ADDENDUM NO. 2

IRONDALE FIRE STATION No. 3

Project Name: Irondale Fire Station no. 3 **Project No:** CWA Project No. 2023-01

Level 1 Plan - Lighting

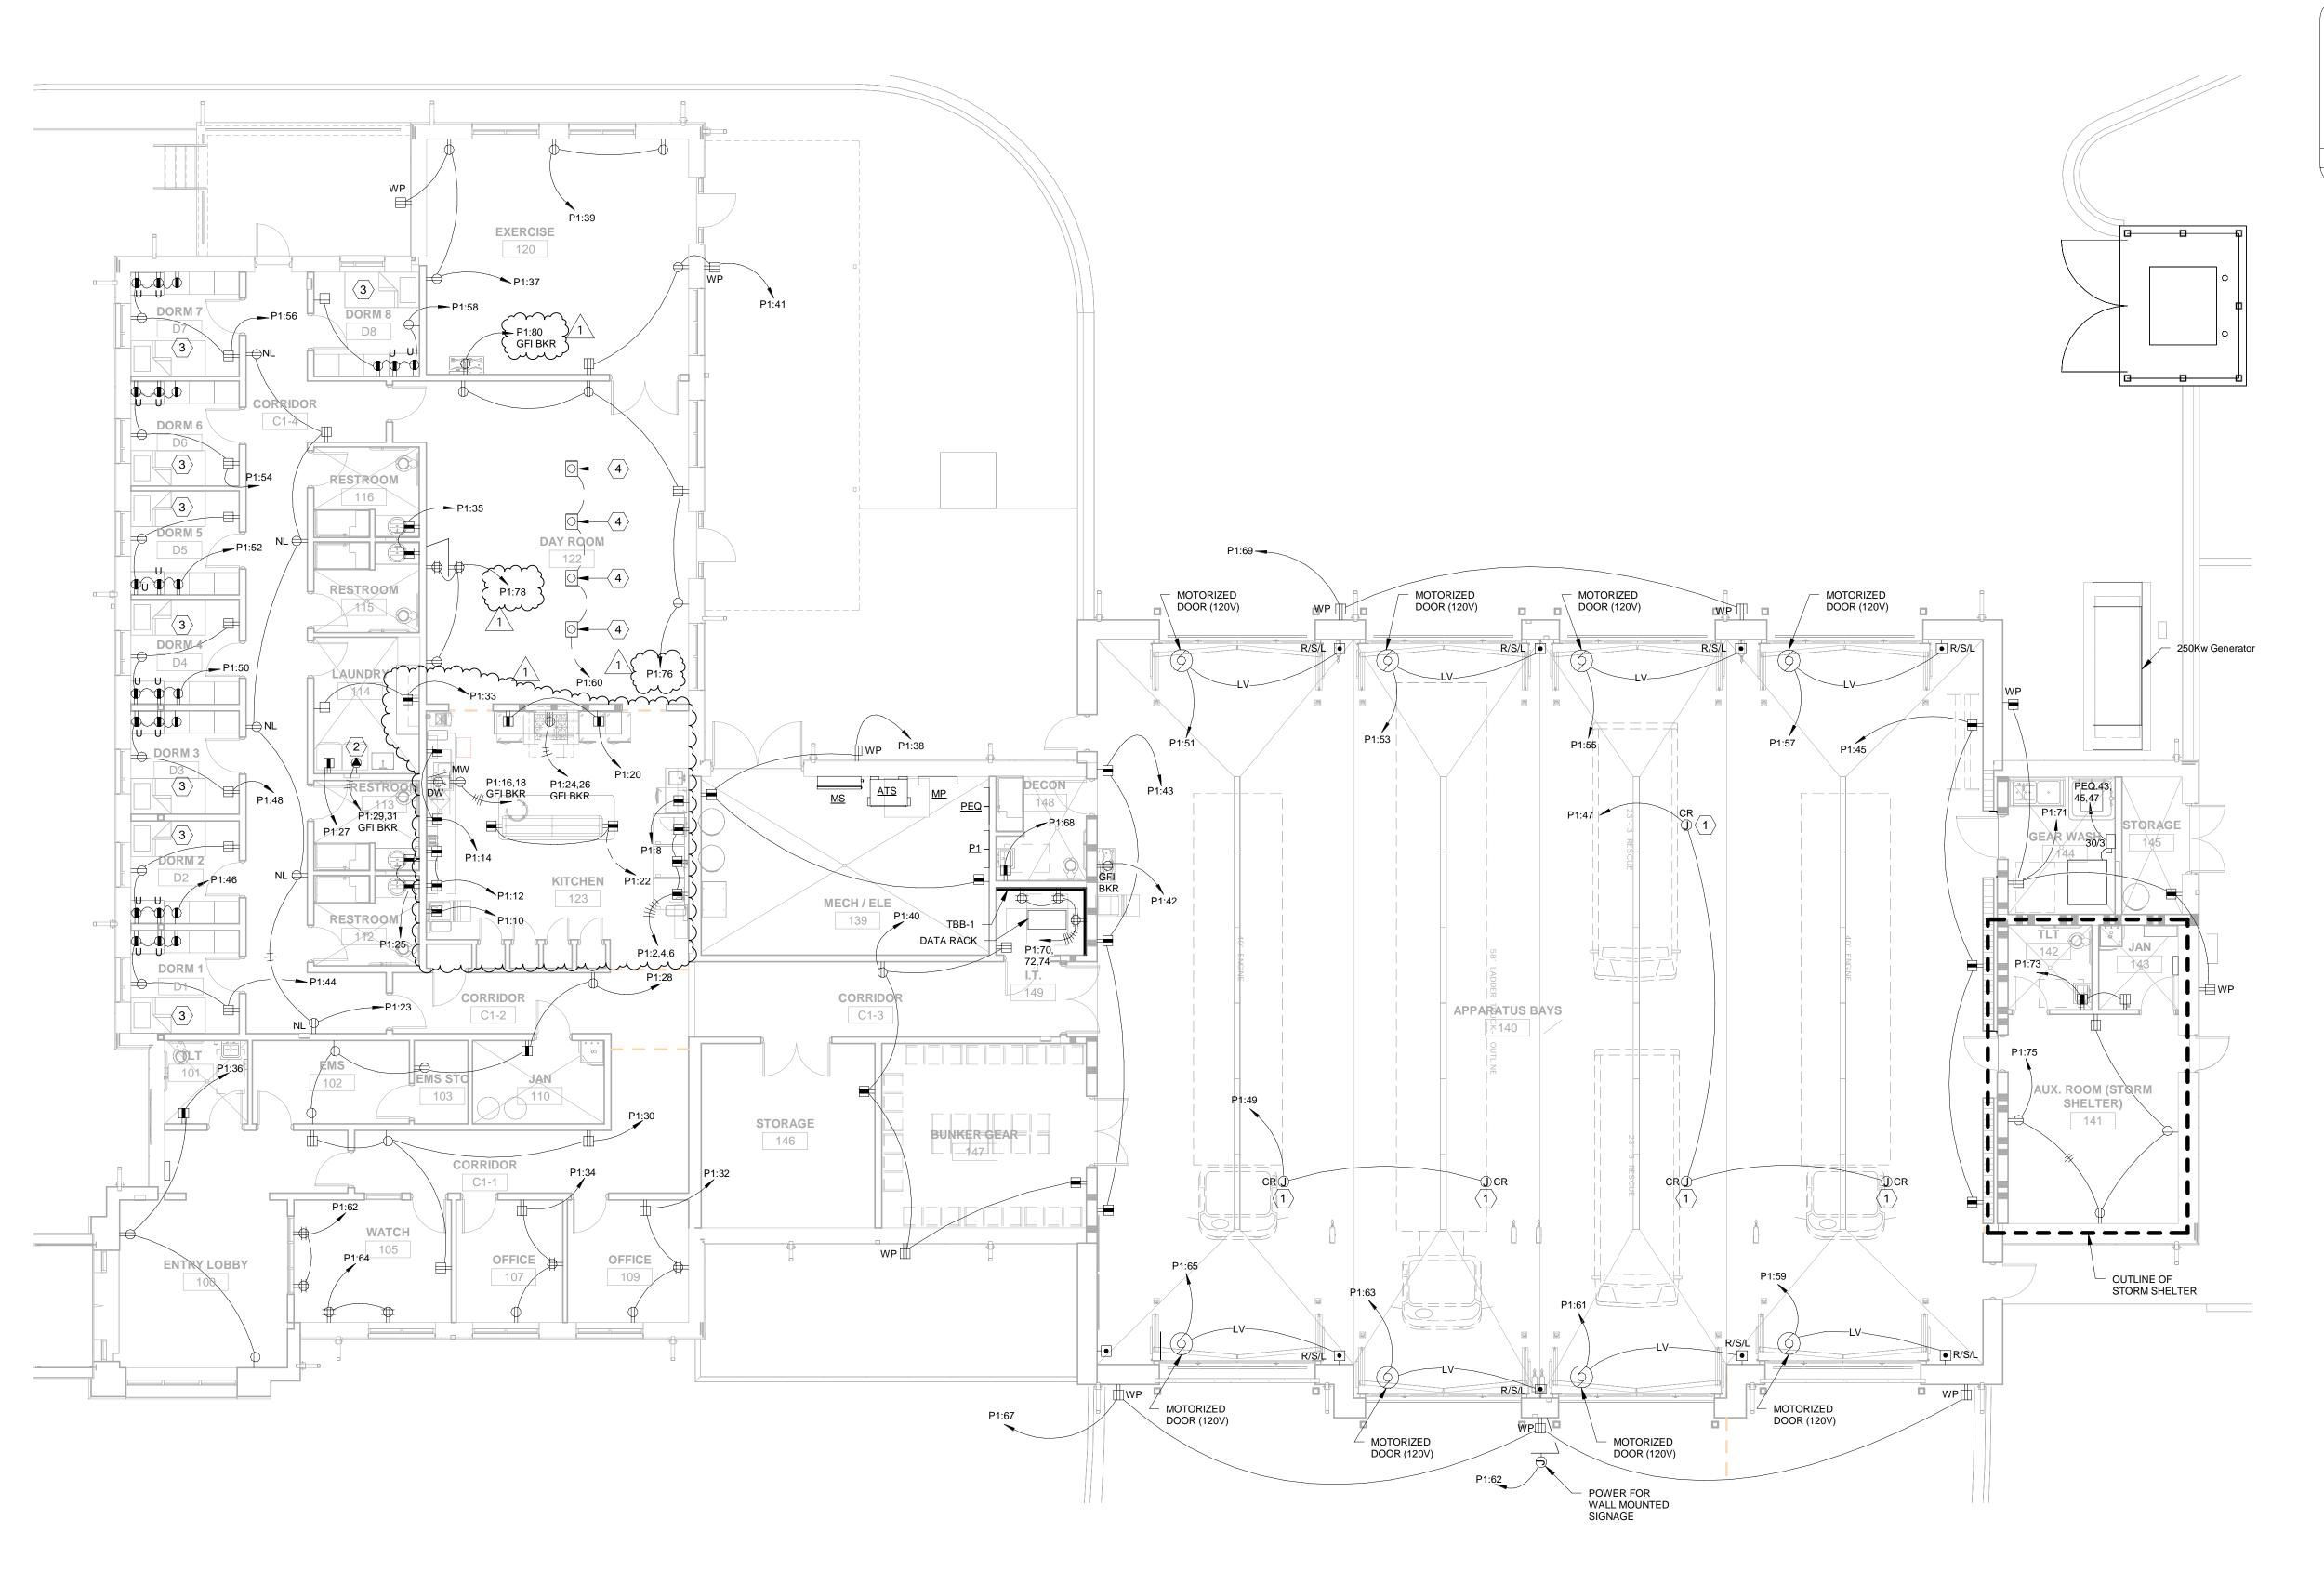
- 14. E101 Site Plan: Updated Plan Note #7.
- 15. <u>E201 Level 1 Plan Lighting</u>: Added battery inverter and applicable notes at main entry door to lobby

Level 1 Plan	- Power
PROJECT NUM	BER:
CWA No. 202	3-01
DATE:	
08.30.24	
DRAWN BY:	CHECKED B

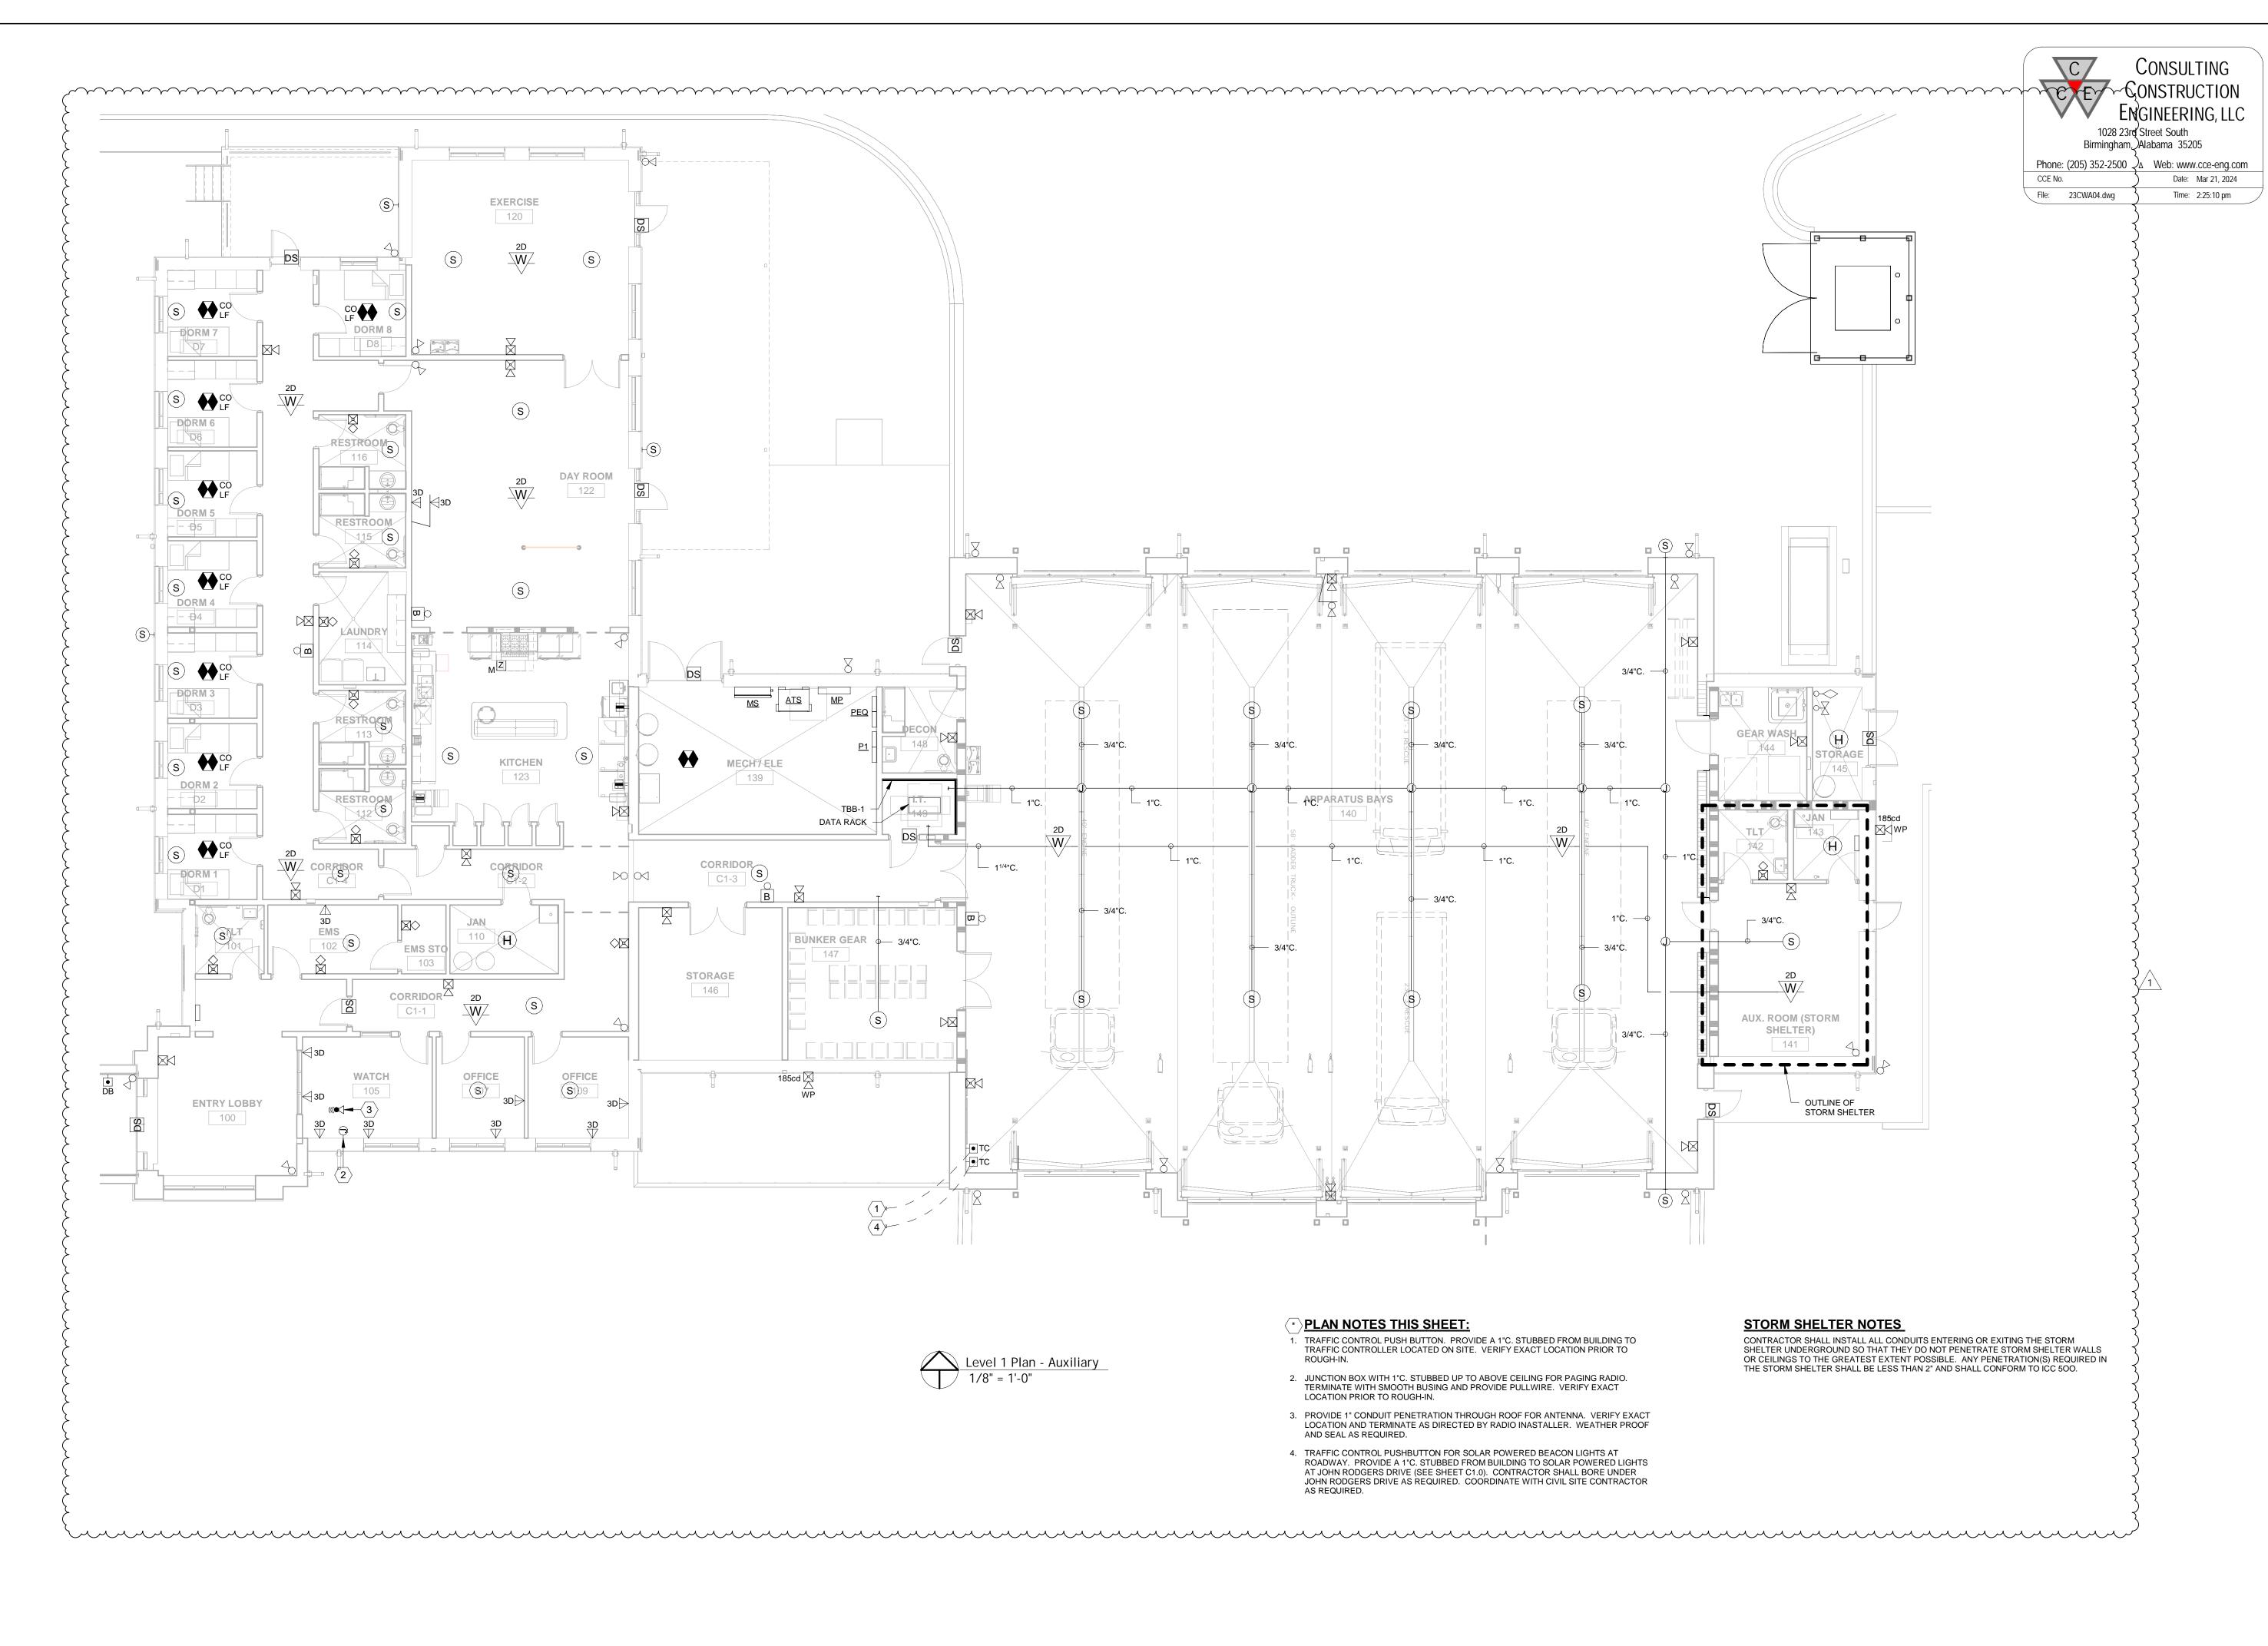
- 16. E202 Level 1 Plan Power:
 - a. Updated power layout at Kitchen
 - b. Updated circuit numbers at Day Room and Exercise Room
- 17. E203 Level 1 Plan Auxiliary:

Level 1 Plan - Auxiliary

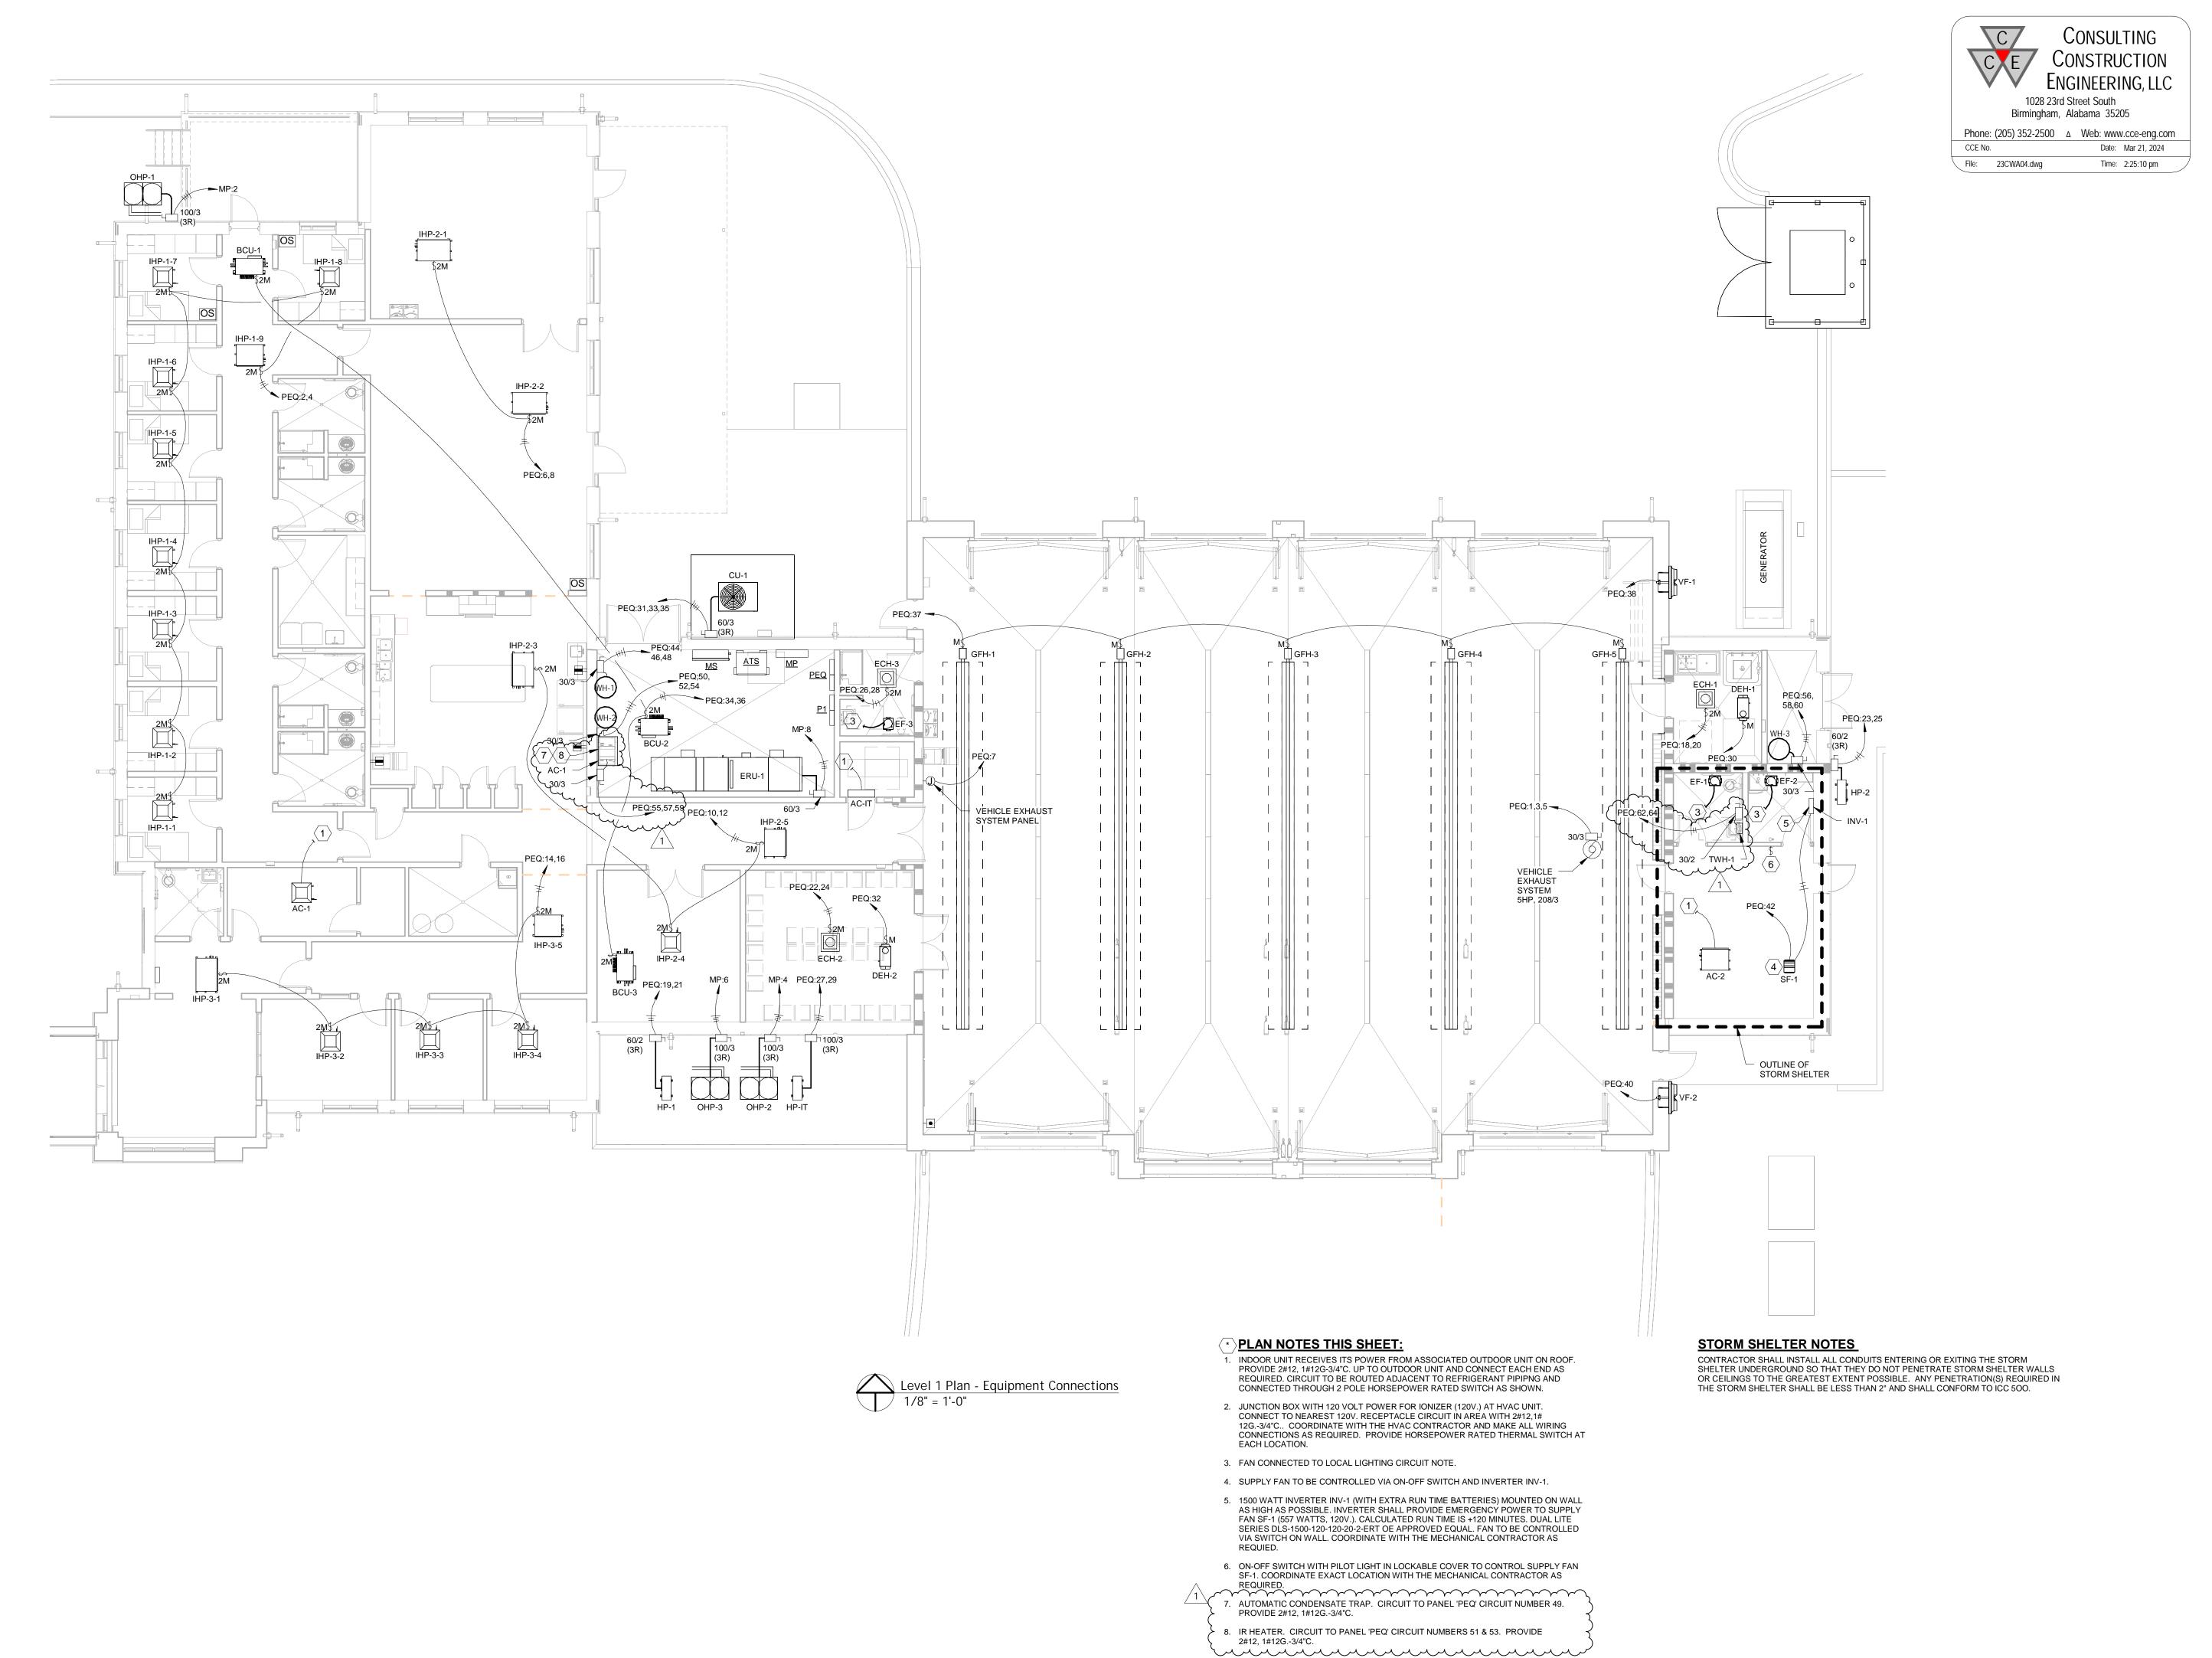
- a. Added speaker rough-in locations for paging system
 - b. Added wireless access point locations
 - c. Added fire alarm flow and tamper switches at fire riser

- d. Added additional traffic control device and applicable plan note
 - e. Removed low frequency fire alarm device at all dorm rooms
 - f. Added combination smoke and carbon monoxide detector with low frequency base to all dorm rooms
